## Purpose of Change—base unit

Re: Application for a Permissive Change Filing with FCC ID: EW780-0835-00.

The purpose of this document is to describe all the changes that are made on **BASE Unit** to the re-skin family models **DL72219** from the original model **RT802** in order to meet the requirements.

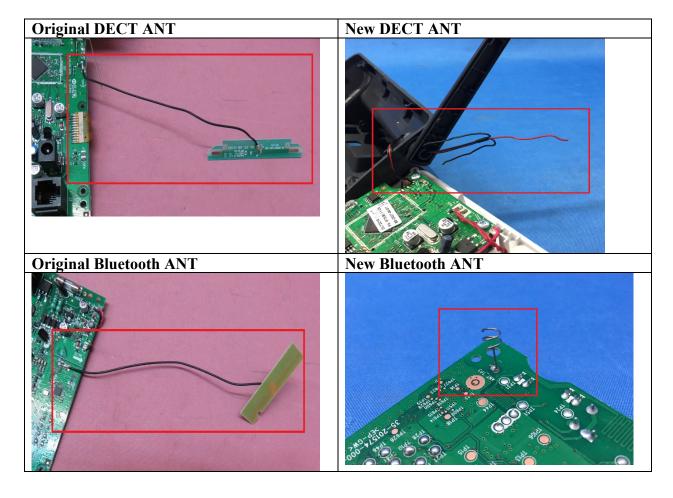
- External appearance is the different
- DECT Mic is removed
- Adaptor change to A318 -060040W-US1 Ao Hai, Tenpao and VTPL
- DECT RF matching circuit is different
- Flash is changed from 25Q32JVSIQ to 25Q64FWSIG
- Shield can for RF module was removed
- Base keyboard is different
- DECT Antenna 1 was changed and Antenna gain changed from 0dBi to 2dBi
- Bluetooth Antenna was changed

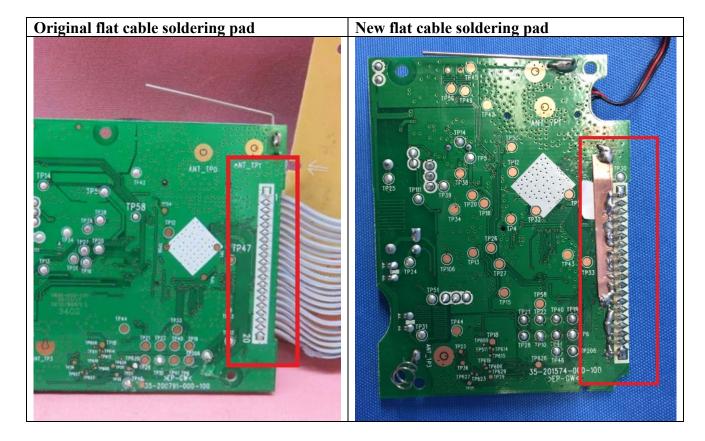
• New flat cable soldering pad, each pins to added with 100pF capacitance to ground to improve EMC.
